The need for timeout in ILT and AN

Comments #131, 184, 543, 545

Jeff Slavick

Figure 178B-8—Training control state diagram

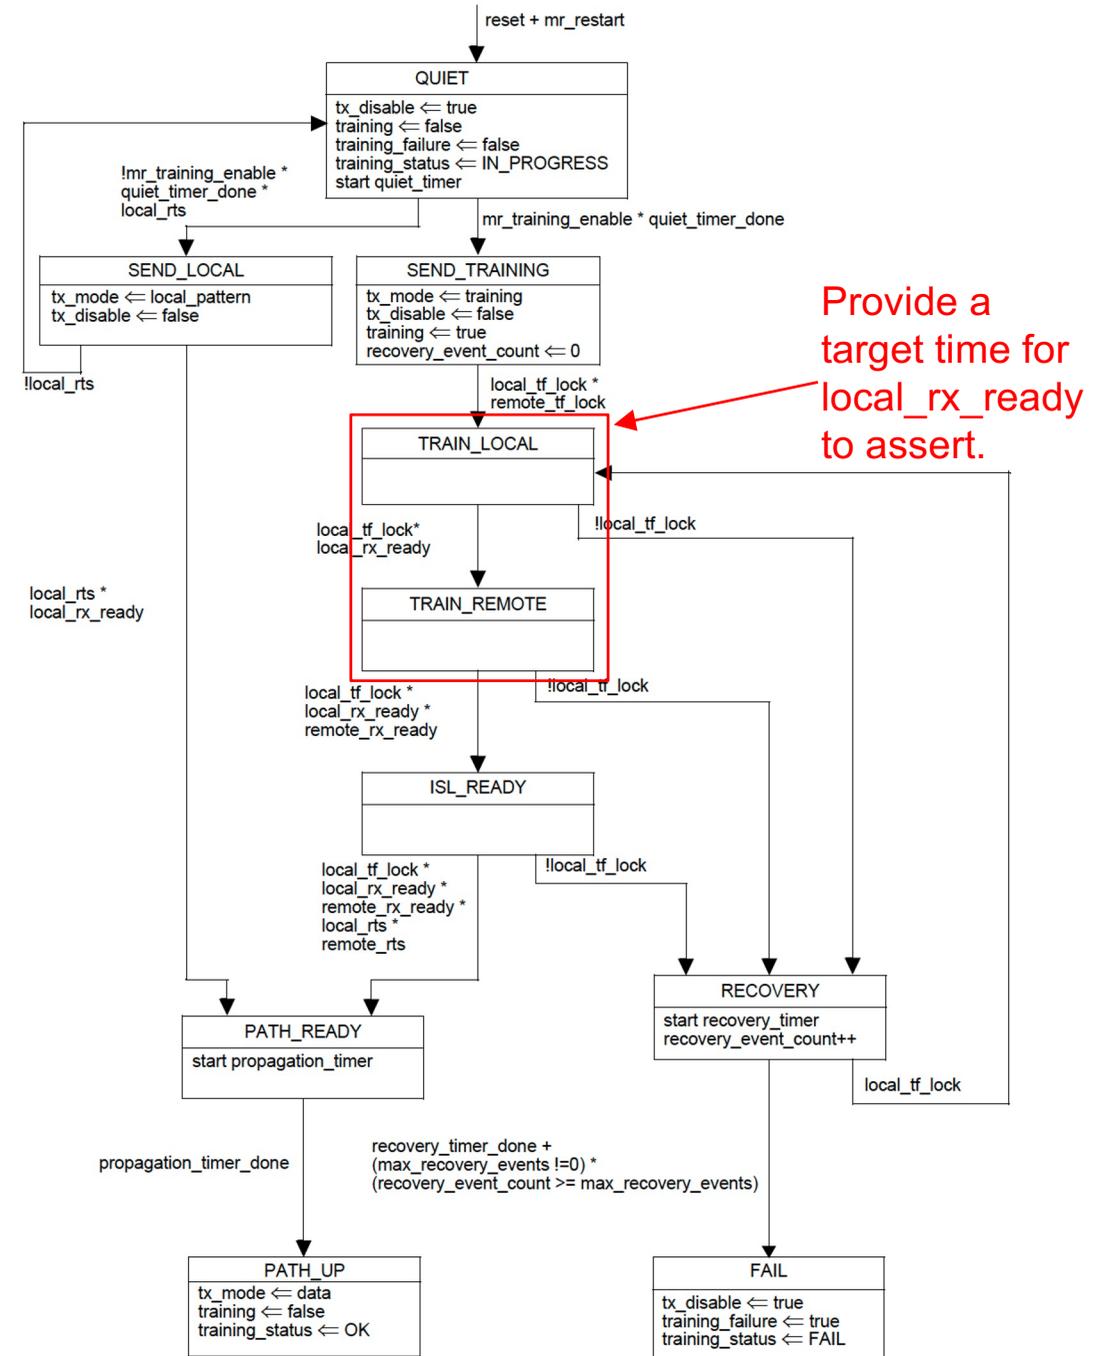
Solution A – no FSM change

- In 178.8.9, 179.8.9, 176C.4.3.1, 176D.7.6, 180.5.12, 181.5.12, 182.5.12, 183.5.12
 - Add sentence “To support reasonable link-up time durations, the time from exiting SEND_TRAINING to entering ISL_READY should be no more than X seconds (see Figure 178B-8).”
- Set the AN link_inhibit_timer to be 3s to 3.1s longer than the expected time local_rx_ready assertion for 200Gbps lanes.

Figure 178B-8—Training control state diagram

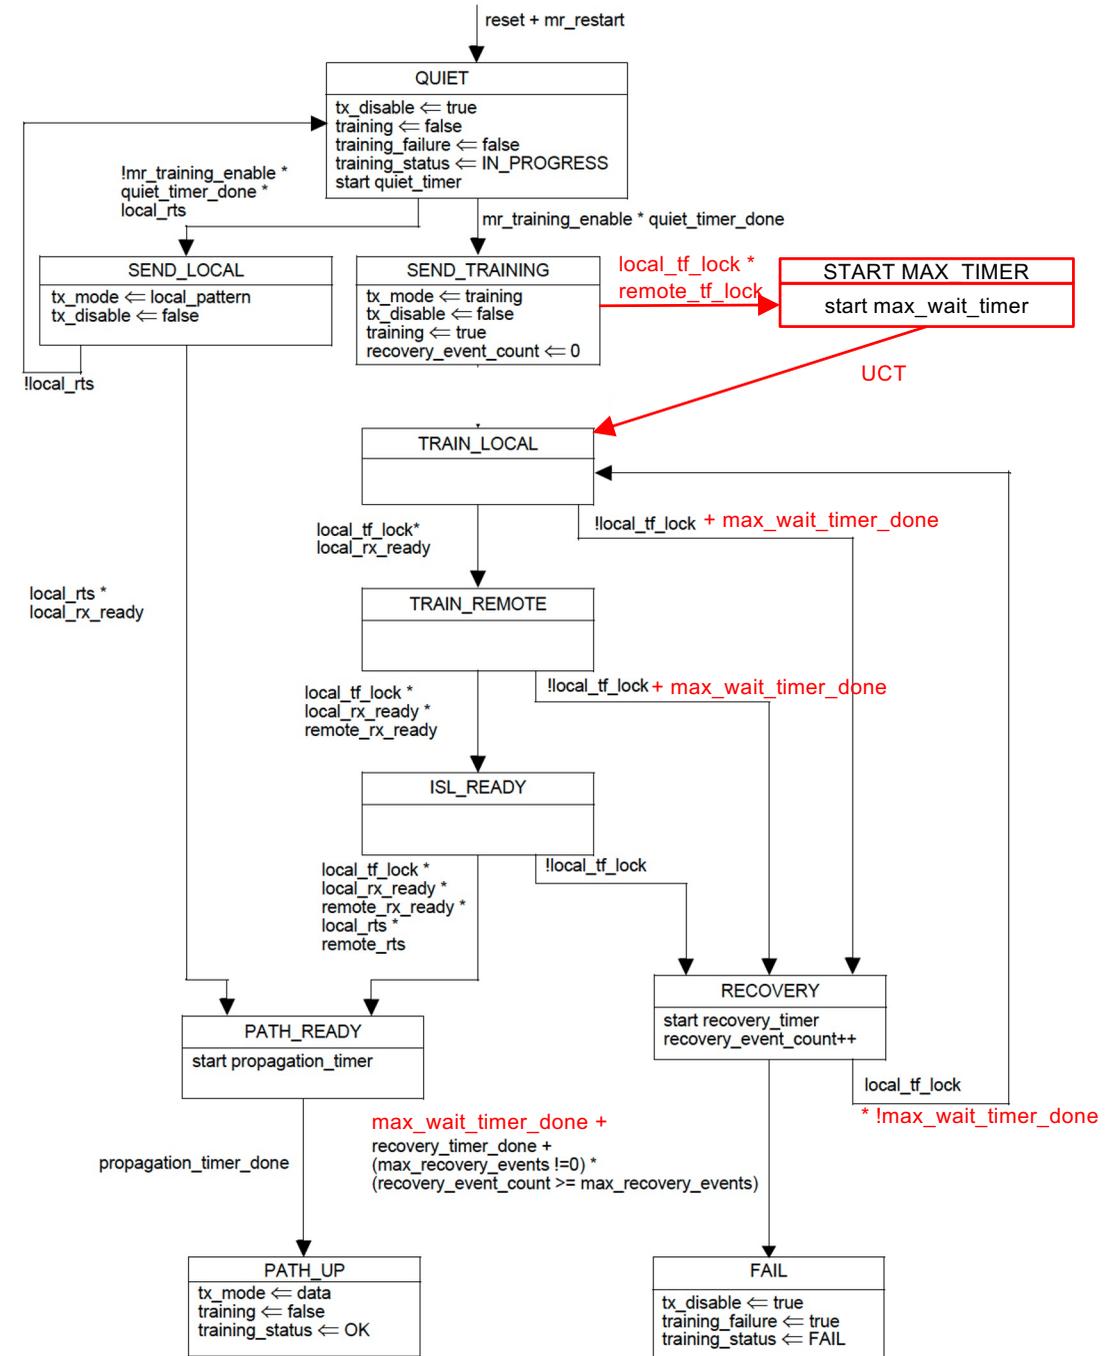
Solution B – FSM update

- In 178B.14.3.3 define max_wait_timer
 - This timer sets the limit for how long the ILT startup protocol is allowed to adapt a link segment. If the timer expires before the ISL_READY state is reached, then a failure to train is indicated. The terminal count of max_wait_timer is set by the AUI component or PMD.
- Change 178B as shown.
- In 178.8.9, 179.8.9, 176C.4.3.1, 176D.7.6, 180.5.12, 181.5.12, 182.5.12, 183.5.12:
 - Add “The duration of the max_wait_timer is X seconds +/- X*1ms.”
- Set the AN link_inhibit_timer to be 3s to 3.1s longer than the max_wait_timer.

Modifications to 178B-8

Diagram adds a state between SEND_TRAINING and TRAIN_LOCAL to start the max-wait_timer.

Adds “+ max_wait_timer_done” to the RECOVERY transition from TRAIN_LOCAL and TRAIN_REMOTE (but not ISL_READY).

Adds “+ max_wait_timer_done” from RECOVERY to FAIL and “* !max_wait_timer_done” from RECOVERY to TRAIN_LOCAL
